## SH10 / Waipapa Road Intersection Improvements

**Road Safety Audit**  
**Scheme/Preliminary Design**

July 2017

**Figure 7: The Waipapa Road and SH10 south entries into the roundabout.**

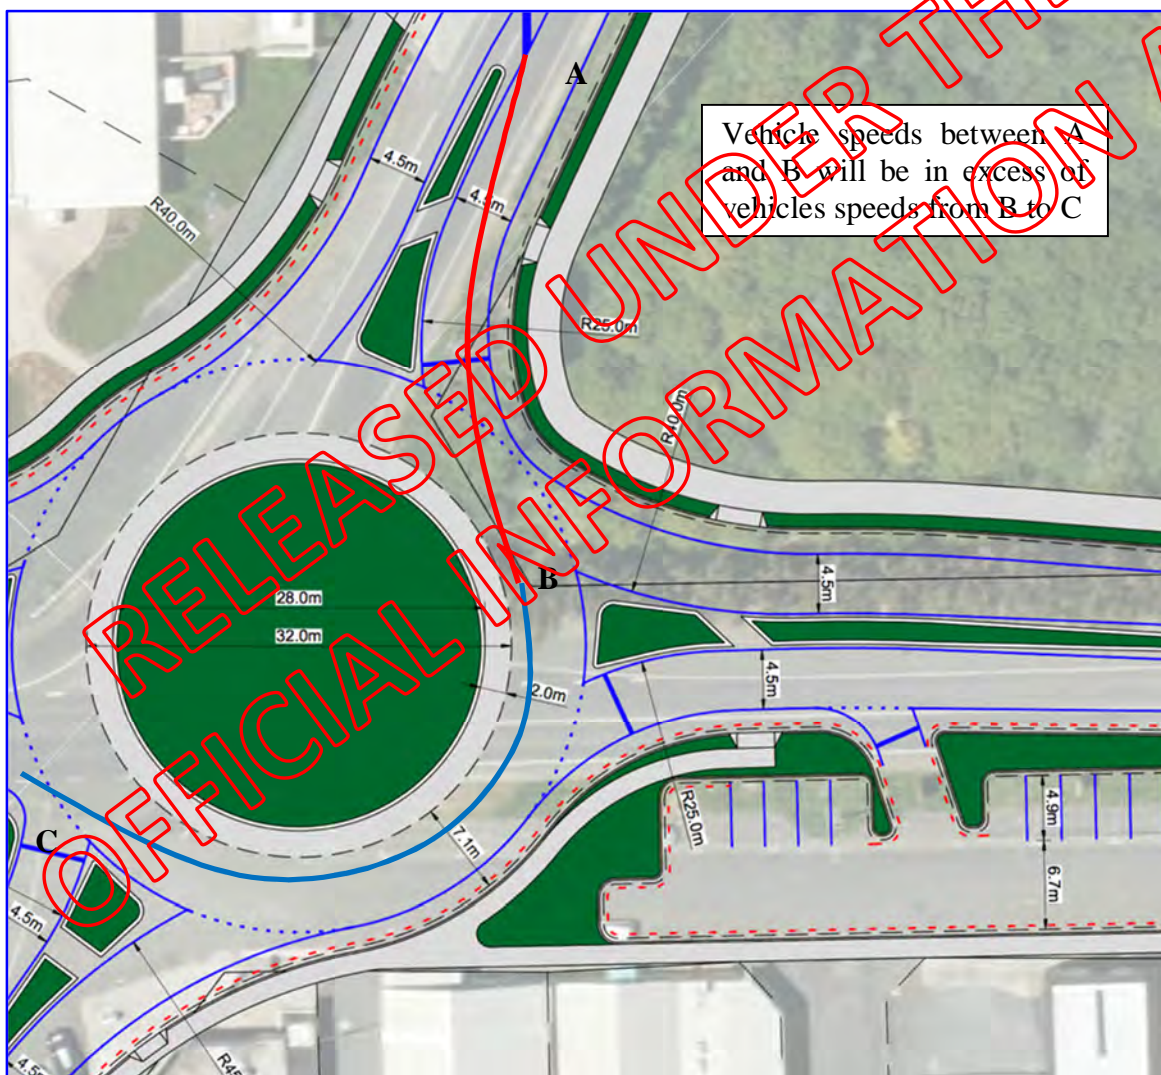
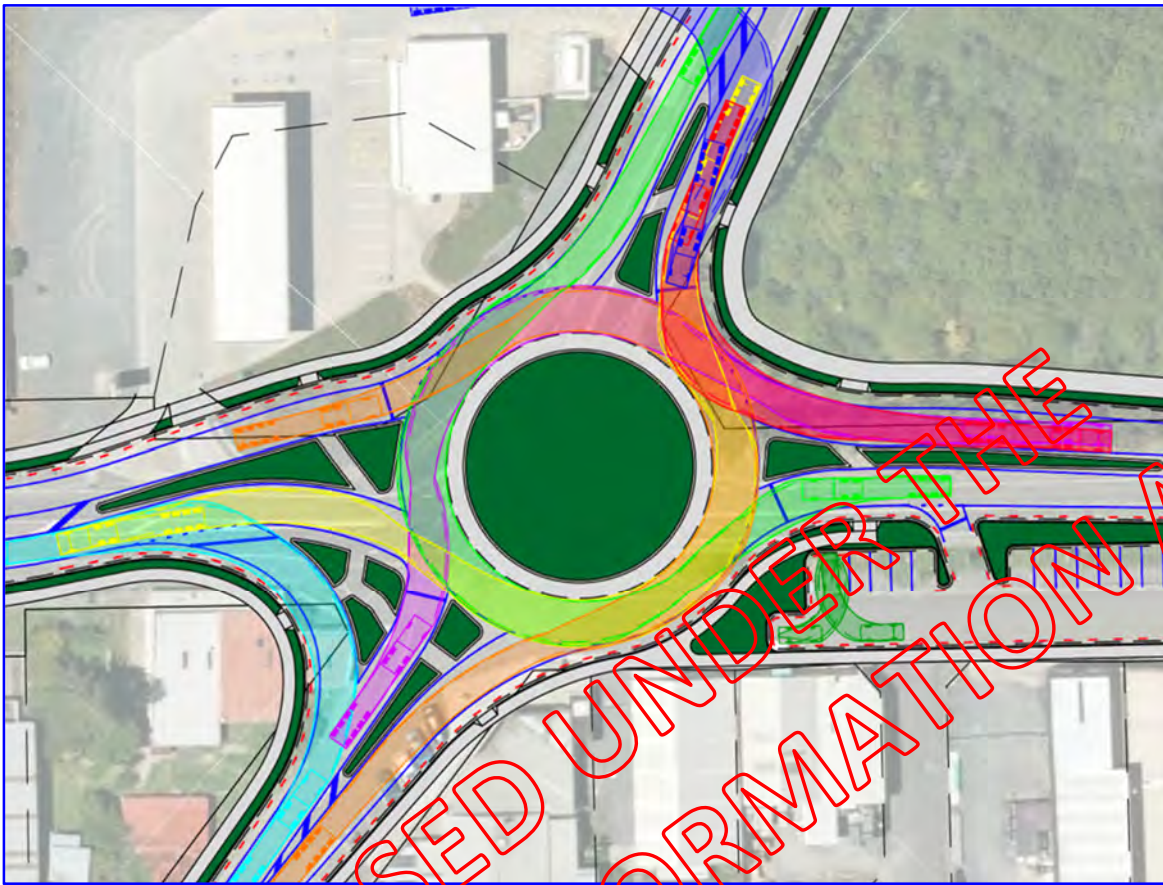
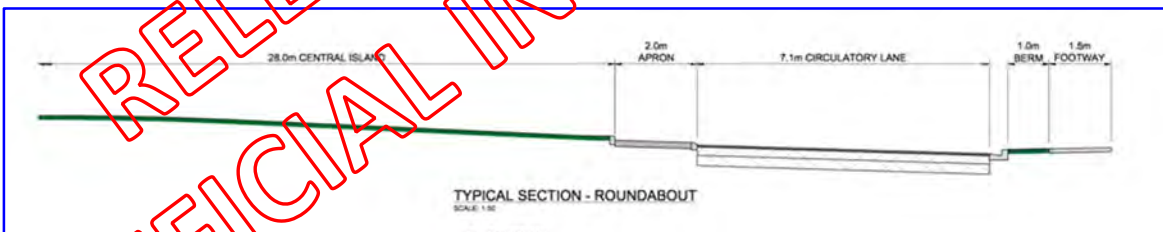
The Waipapa Road and SH10 south entries into the roundabout have relatively low deflection (refer to **Figure 7**). Drivers will be able to enter the roundabout at higher speeds and be forced to slow quickly into the circulatory lane. This could increase the likelihood of loss of control. Best practice is to offset the approach entry paths to the left of the central island to manage entry speeds into the circularly path with the minimum vehicle speed being achieved at the roundabout limit line.

The skewed roundabout configuration results in faster left turn layouts on the obtuse angled exits. Faster exit speeds increase the likelihood of loss of control type crashes and the potential for higher speed crashes involving pedestrians crossing the road near the exits.

The design should include the consideration of the speed path profiles through the roundabout to demonstrate safe speeds, through both the circulatory path and on the higher speed left turns that are on the obtuse angles.

The roundabout central island also includes an apron, although the vehicle tracking plan indicates that the design vehicle does not track the apron (refer to **Figure 8**). A kerb is detailed between the circulatory lane and the apron (refer to **Figure 9**). Kerbs next to roundabout islands can be hazardous for motorcyclists, particularly if the entry path offsets, referred to above, have not been provided. The apron should either be removed if it is not required for vehicle tracking, or the kerb removed to improve safety for motorcyclists.

- a) *Assess the speed path profiles through the roundabout and provide safe speeds, through both the entry-circulatory path, which should be sufficiently offset from the central island, and on the higher speed left turns that are on the obtuse angles.*

- b) *Review the need for an apron on the roundabout island. If it is retained, remove the kerb between the circulatory lane and the apron.*

| <b>Designer Response: Agree. To be addressed at Detailed Design.</b> |               |                         |               |

| <b>Designer Response: Agree. To be reviewed at Detailed Design.</b> |                   |                         |               |

**Figure 10: The pedestrian desire line from SH10 to Skippers Lane.**

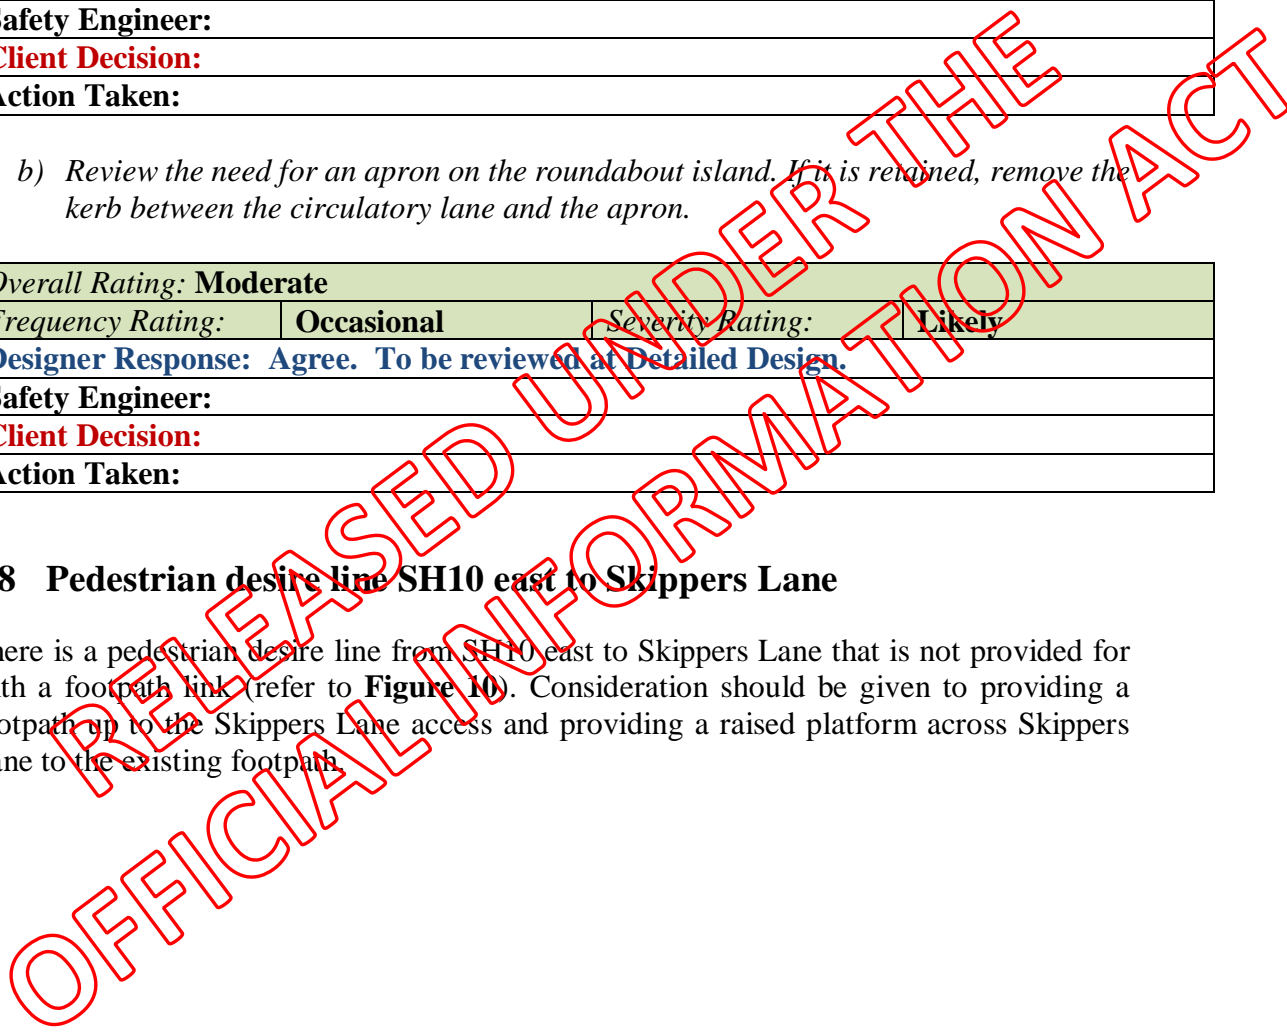
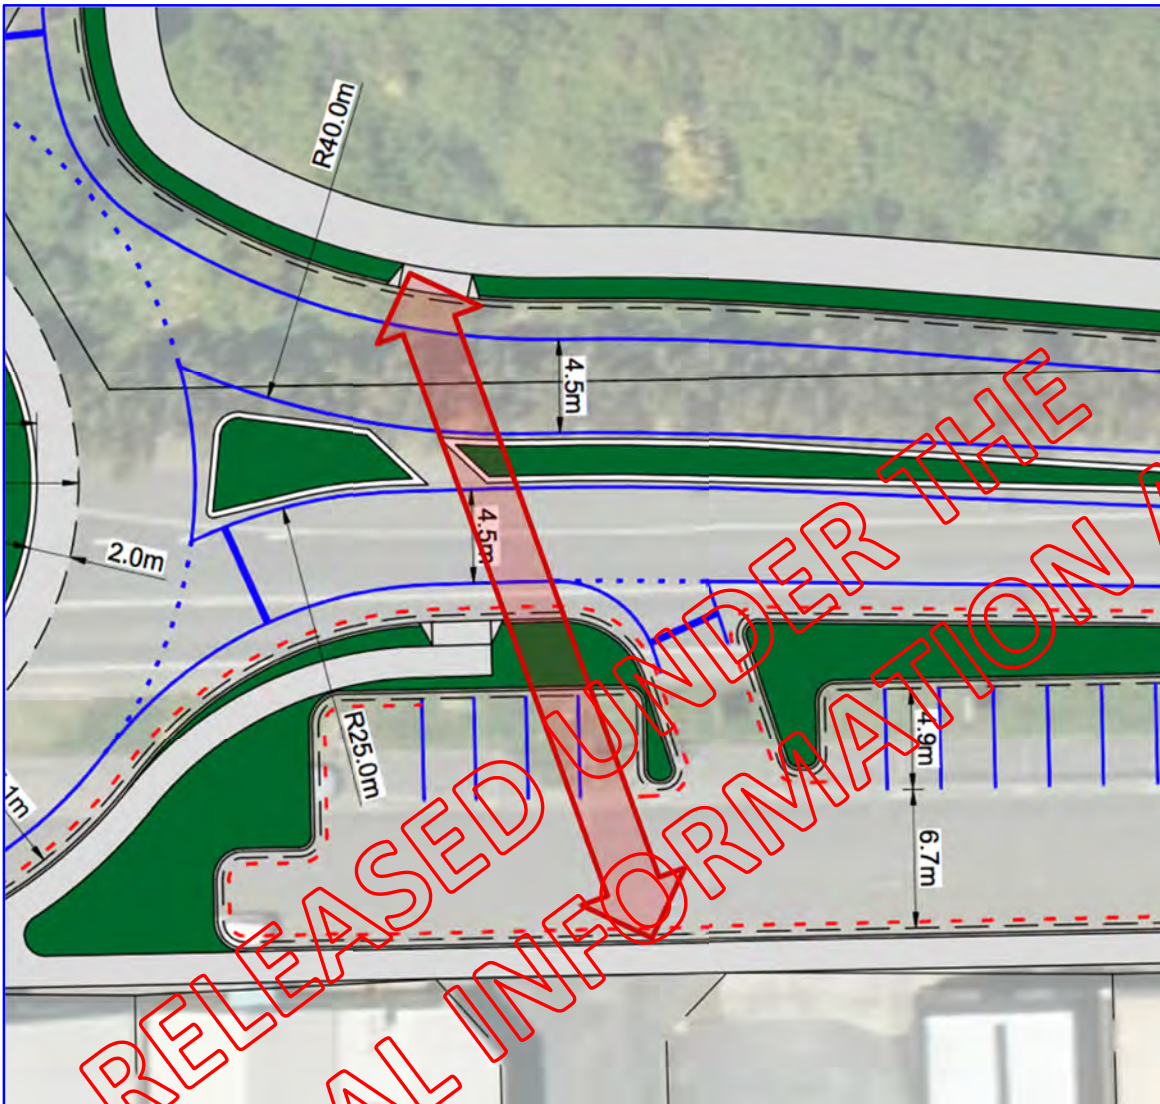
There is a pedestrian desire line from SH10 east to Skippers Lane that is not provided for with a footpath link (refer to **Figure 10**). Consideration should be given to providing a footpath up to the Skippers Lane access and providing a raised platform across Skippers Lane to the existing footpath.

*Provide a more direct footpath link from SH10 east to Skippers Lane, possibly with a raised platform across Skippers Lane. Ensure that the path is aligned with the pedestrian desire lane.*

| <b>Designer Response: Agree in part. Pedestrian facilities to be assessed as part of Detailed Design.</b> |                   |                         |               |

**Figure 12: Typical kerb detail near footpath.**

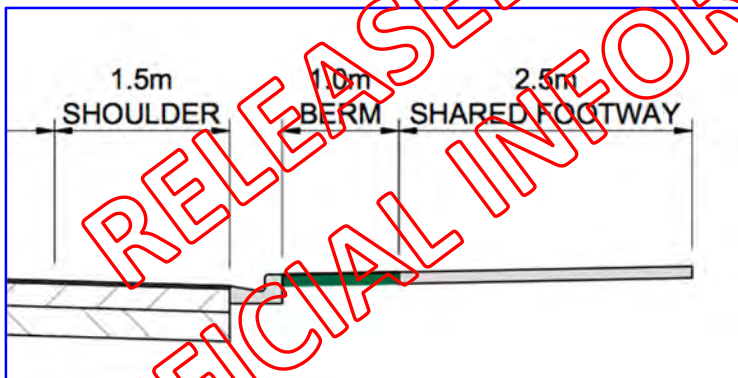
The typical details indicate the use of a vertical kerb profile near the footpath (refer to **Figure 12**). The footpath is next to the road on the left turn from SH10 into Waipapa Loop Road. Vertical kerbs can snag errant vehicles, causing them to mount a footpath and hit pedestrians. Semi-mountable kerbs enable drivers to more easily regain control and avoid mounting the footpath. Vertical kerbs also prevent cyclists mounting the kerb to avoid being hit by vehicles. Semi-mountable kerbs should therefore be use as the preferred safe system treatment.

*Provide semi-mountable kerbs in place of vertical kerbs.*

| <b>Designer Response: Disagree. In an urban environment, at lower speeds, the vertical kerb will redirect errant vehicles, whereas a semi-mountable kerb will make it easier for an errant vehicle to hit a pedestrian. It is also highly unlikely that a cyclist would be aware if they were about to be hit by a car, let alone have time to</b> |                   |                         |               |

do anything about it. The use of semi-mountable kerbs also encourages driving over, or parking on, the berm/footpath. This is even more likely at this location where on-street parking is being removed.  
 A possible compromise could be to consider providing semi-mountable kerbs at the pinch-points only, on the apexes of the entry and exit radii.

**Figure 16: The southern access to Skippers Lane.**

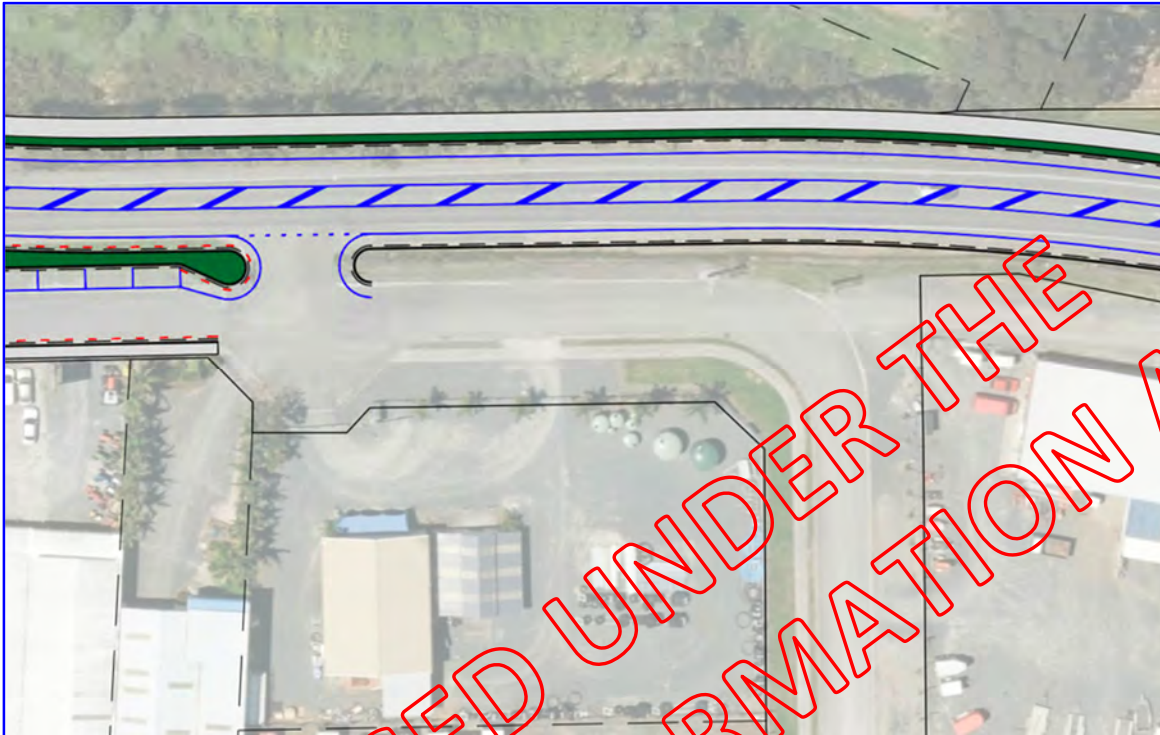
The southern access to Skippers Lane requires a difficult 180-degree left turn from SH10 south to the southern end of Skippers Lane (refer to **Figures 15 and 16**). These create conflicts with other vehicles accessing properties off Skippers Lane. Moving the access

about 70 m southwards to align with the 90 degree turn on Skippers Lane would improve accessibility and safety.

| <b>Designer Response: Agree. To be considered during Detailed Design.</b> |                   |                         |                 |

**Figure 17: The SH10 north approach to the roundabout tie-ins to the existing central flush median treatment.**

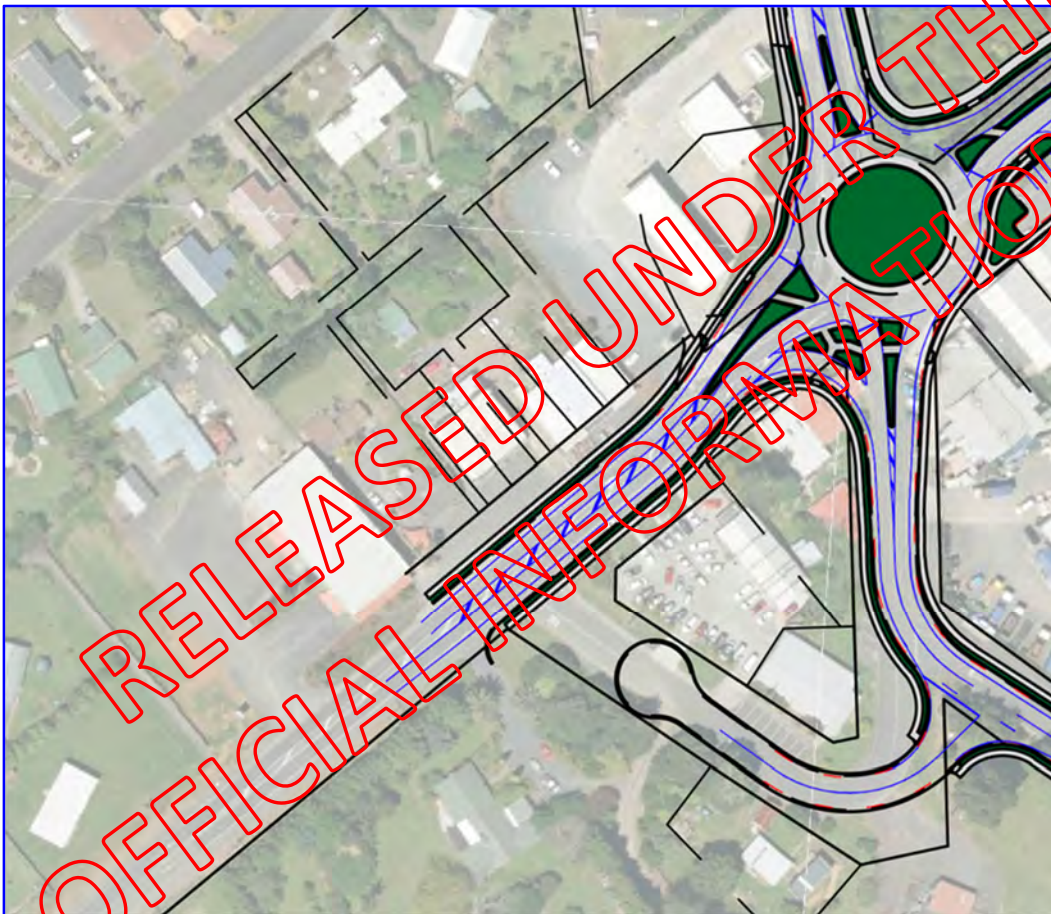
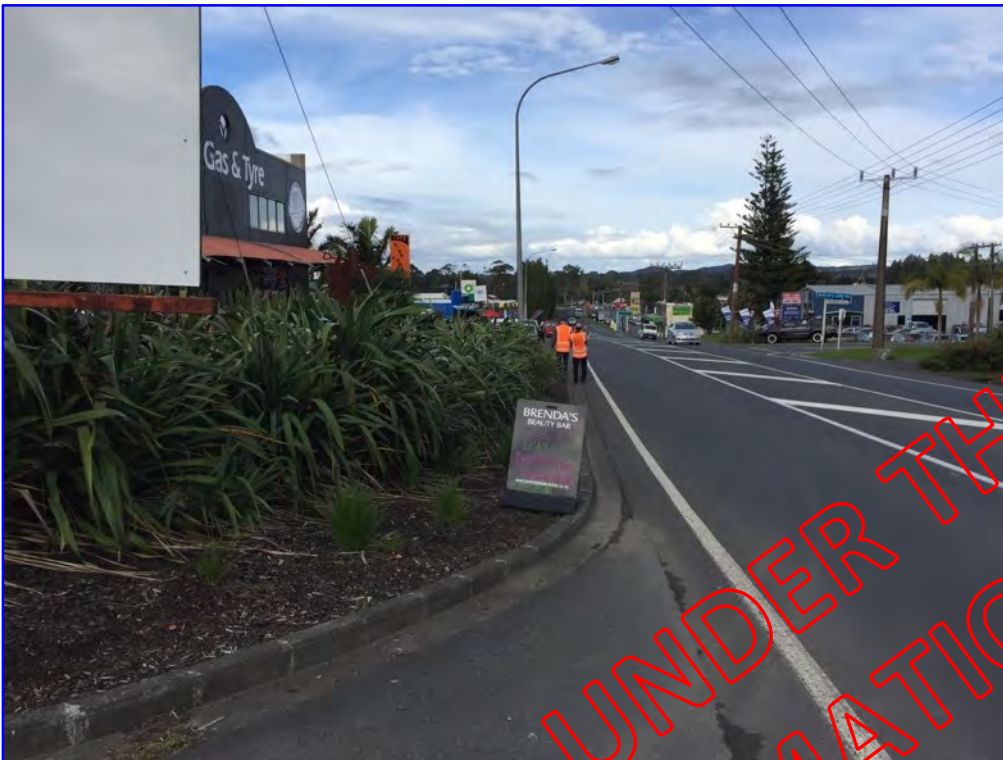
The auditors consider that the use of additional raised central islands on the north approach to the roundabout would be beneficial in:

- Creating additional side friction to reduce vehicle speeds;
- Providing better definition and control of access to and from SH10; and
- Enabling the provision of refuge areas for pedestrians crossing SH10.

*Provide additional raised central islands on the SH10 north approach to the roundabout.*

| <b>Designer Response: Agree. To be assessed during Detailed Design.</b> |               |                         |               |
